# UNITED STATES PATENT AND TRADEMARK OFFICE

APPLICATION NO.	FILING DATE	FIRST NAMED INVENTOR	ATTORNEY DOCKET NO.	CONFIRMATION NO.
10/604,900	08/26/2003	Susan P. BEACHAM	MSG4	1899

<b>Office Action Summary</b>	Application No. 10/604,900	Applicant(s) BEACHAM ET AL.	
	Examiner William L. Miller	Art Unit 3677

## DETAILED ACTION

6/6

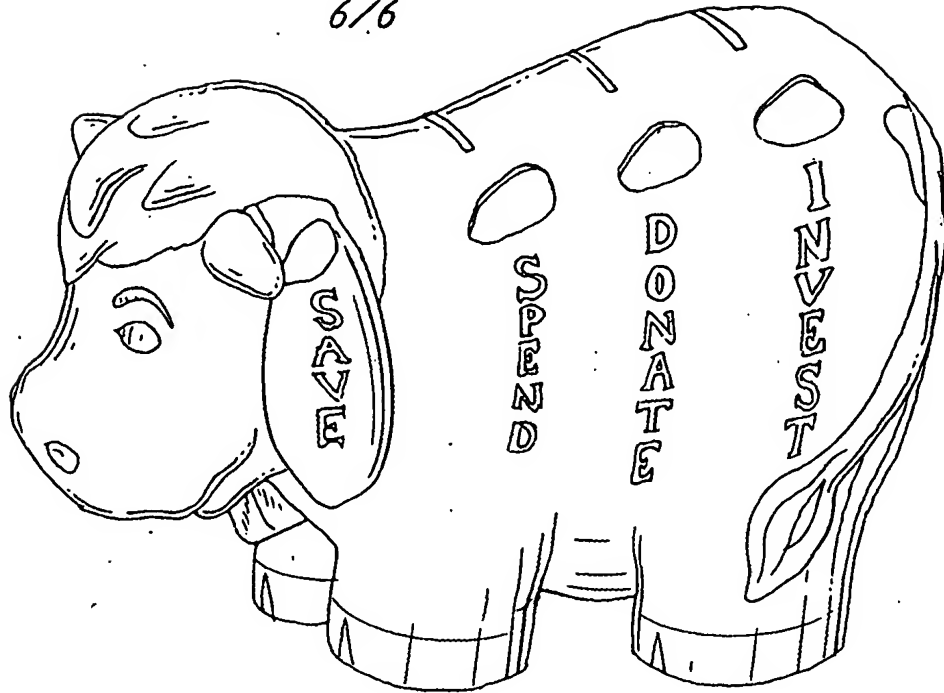
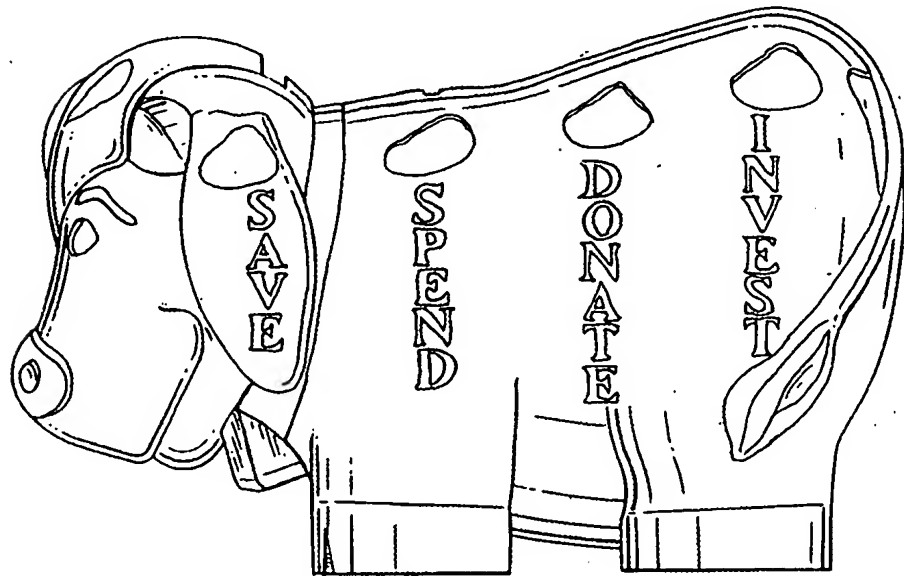
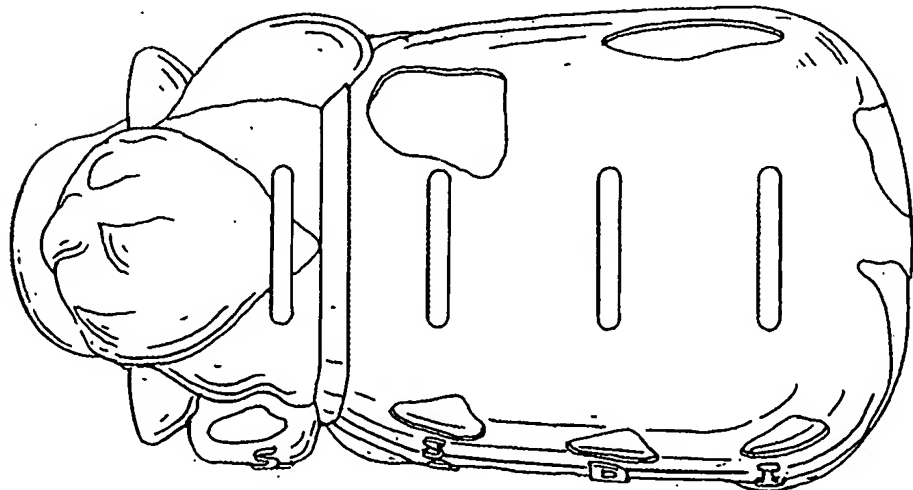
2. The drawings received on 03-16-2005, namely sheet 6/6 and Figs. 6-8, are objected to as introducing new matter, specifically a compartment located in the ear of the cow. Consequently, these drawings have not been entered, and the originally filed drawings remain objected to under 37 CFR 1.83(a). The drawings must show every feature of the invention specified in the claims. Therefore, the cow (claim 9) must be shown or the feature(s) canceled from the claim(s). No new matter should be entered.

NOT APPROVED W.M. 7/6/05
